Technical Service Bulletin

94 Daytime running light (DRL) inoperative, DTC 02895 and/or 02897 is stored in the central electrics control module

94 19 06 2032184/8 April 30, 2019. Supersedes Technical Service Bulletin Group 94 number 16-80 dated September 7, 2016 for reasons listed below.

Model(s)	Year	VIN Range	Vehicle-Specific Equipment
Q5	2013-2017	All	LED Daytime Running Lights

Figure 3. Current (left) and early (right) style LED DRL units.

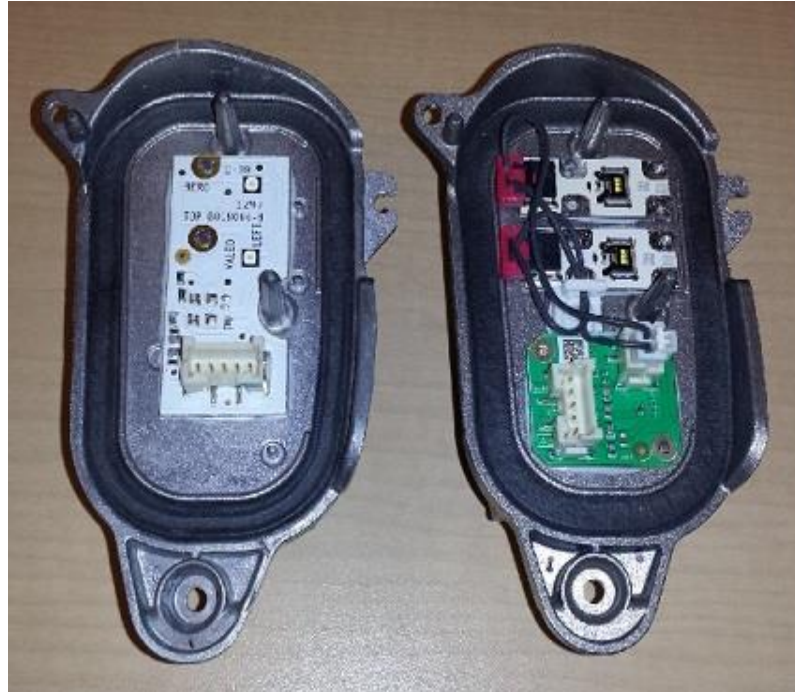
As of March 12th, 2013 production, the LED unit with heat sink has been updated (Figure 3). If a failure

occurs, these parts do *not* need to be replaced in pairs.

The appearance of the replacement part for the LED DRL has changed, but functionality is the same. If an LED DRL needs to be replaced, they do not need to be replaced as a pair.
